**TOWN OF BAY HARBOR ISLANDS
MORRIS N. BROAD COMMUNITY CENTER
1175 95TH STREET
BAY HARBOR ISLANDS, FL 33154**

DESIGN REVIEW BOARD

**November 7, 2023
7:00 PM**

Subject: Existing Single-Family Residence – Renovations
Exterior Facade / Front Entry Feature Modifications
1310 101st Street
Bay Harbor Islands Acct. No.: SPR23-000004
MMPA Acct. No.: 01-0702-1153

ELEVATIONS - FRONT
AND REAR

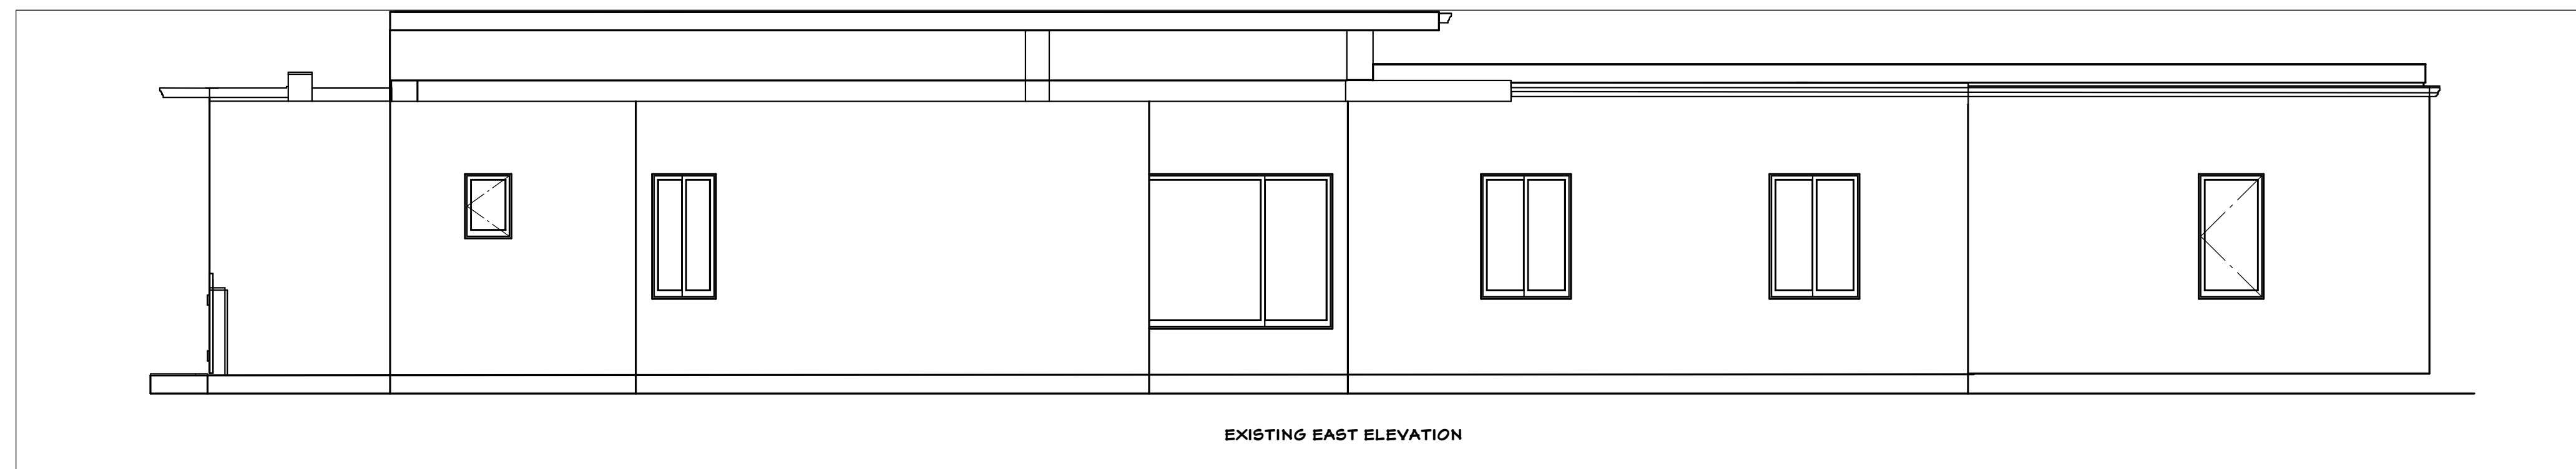
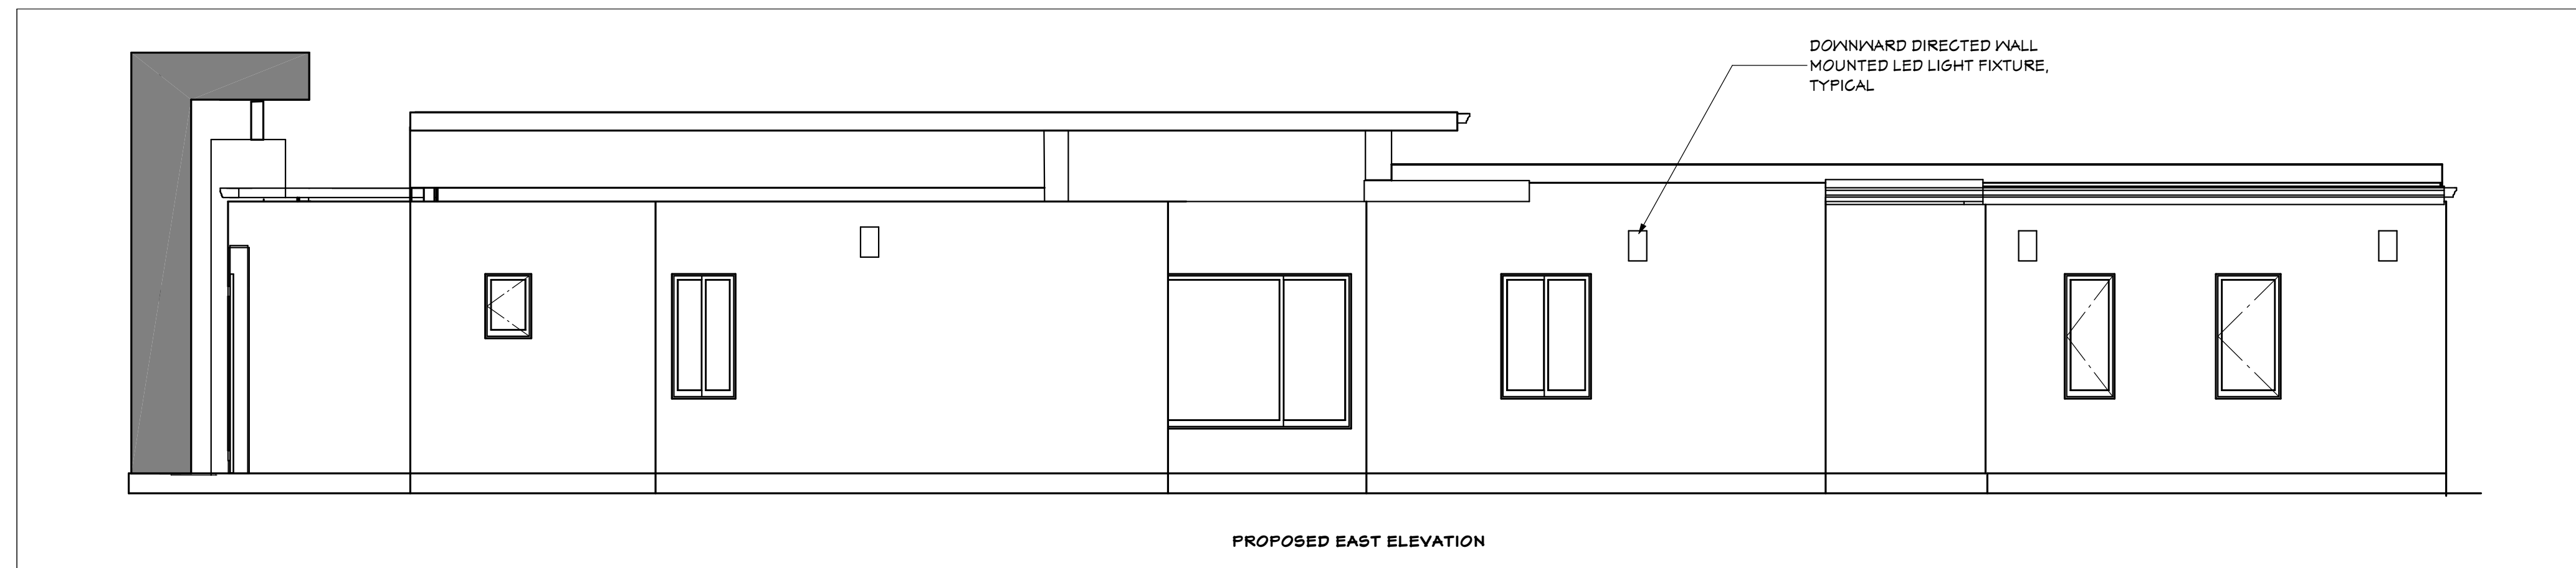
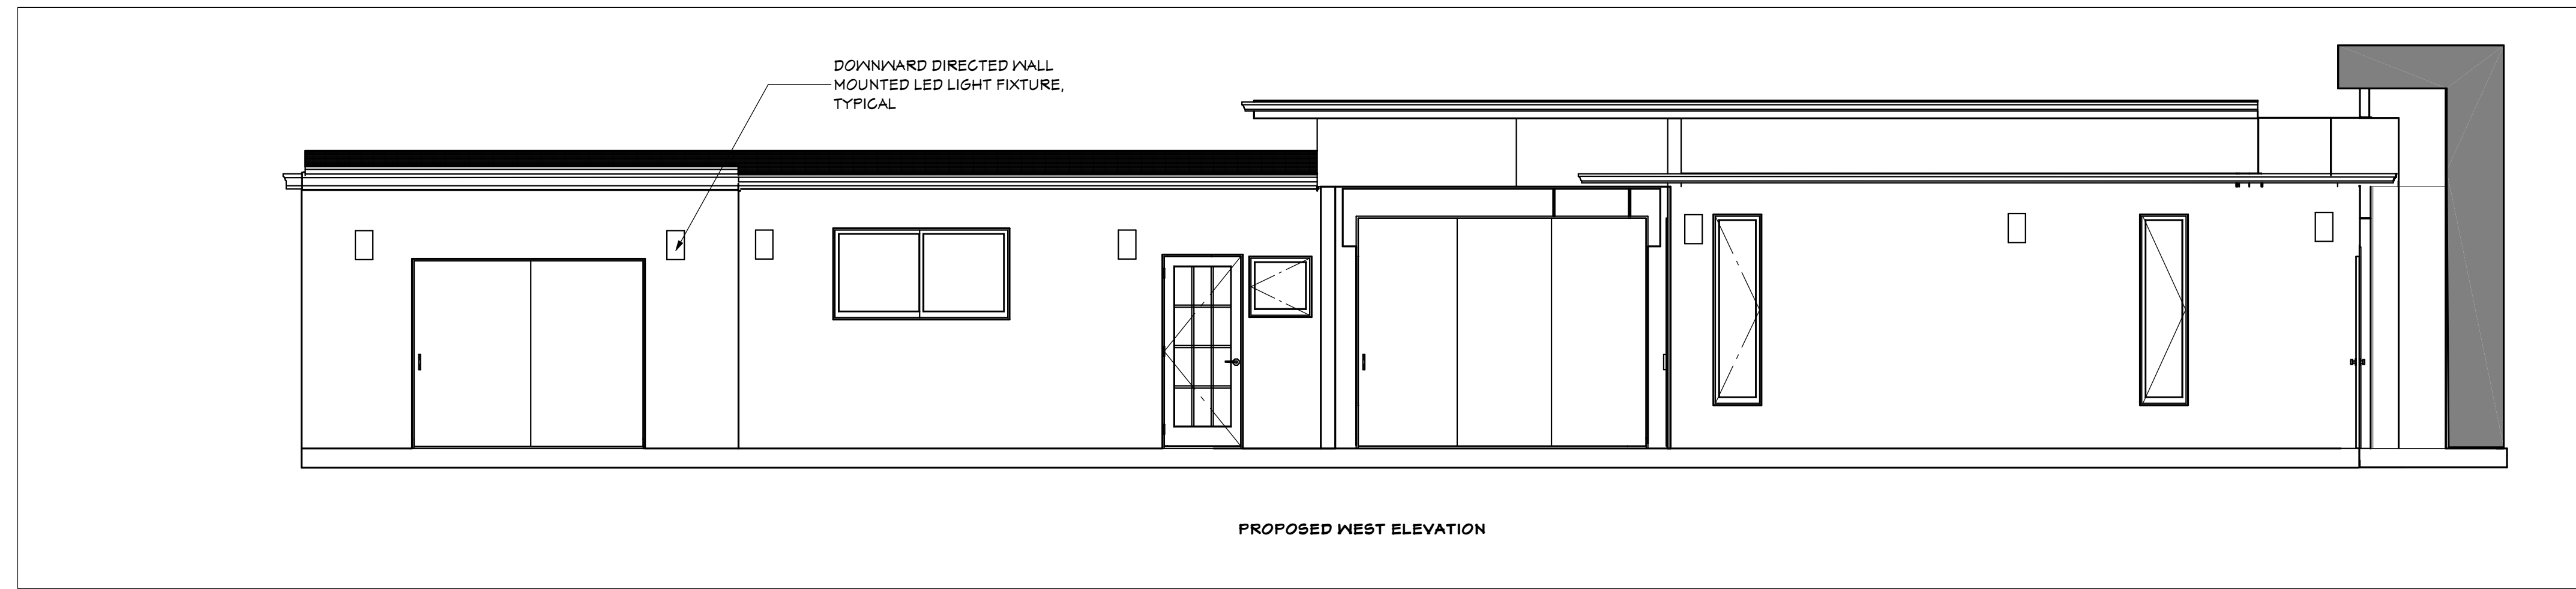
Not clearly noted on the initial plans submitted but observed are proposed linear lighting fixtures framing some of the house features (arches / other). The Town’s Lighting Code state as follows:

The Town staff has attempted to work with the owner and their design professional (engineer) to ensure the proposed LED strip lighting fixtures are recessed into the façade elements and fully concealed. As to the outlining of some of the home's elements, the Town Code generally prohibits this practice, but allows the DRB to consider specific requests. It is not uncommon for property owners to provide soft architectural lighting (ground uplighting / other) but not as proposed.

by the DRB prior to permits. The proposed linear front facade site lighting detail was recently noticed (not shown on site plans) and the applicant was informed the DRB would need to review / approve that feature as per Sec. 23-19 of the Code. The applicant is now requesting DRB approval for the front entry canopy feature, substantial door & window changes (front façade) and arches, and the linear LED strip lighting requested to be placed in recessed channels on the new front façade features.

As related to the applicant's request for the proposed linear strip LED lighting, while it is fairly common for homeowners / landowners to provide accent lighting of building features, landscaping and other items accent lighting is usually placed in enclosed fixtures in ceilings / under roof eave fascia, or ground mounted fixtures aimed upward at the structure or landscape being featured. MMPA is not aware of linear lighting being installed on any building, let alone a single-family house, as is proposed. MMPA / Town staff worked with the owner / designer to ensure the actual linear light fixtures were completely hidden from street view in recessed channels with coverings to shield the light fixtures. In general, the Town's stated policy is to prohibit lighting outlining architectural features. MMPA assisted the Town in writing the Lighting Code and feels the Code expresses the community's desire on this subject. MMPA recommends the DRB consider the above in their deliberations. The applicant has recently provided a justification letter for the LED strip lighting waiver and their version of the history of this house renovation. See attached.

- 1) This approval is based on the latest revised Site Development Plan drawings prepared by Michael Spicyn, P.E. dated Oct. 10th, 2023, with any modifications required by the Board. Any future modifications to the above plans shall be reviewed by Town staff / MMPA and may require re-approval by the DRB if felt to be substantial.
- 2) As related to the applicant's request to install linear strip lighting around some of the front façade architectural features (arches / other) the DRB per Sec. 23-19(d) is required to review / approve this type of lighting. No portion of the linear strip lighting fixtures / bulbs can be visible as they must be integrated into the building façade. Absent of the DRB's approval no linear strip lighting is allowed on the house. There are other acceptable means listed in the Code for accent building up-lighting and limitations on light emission.
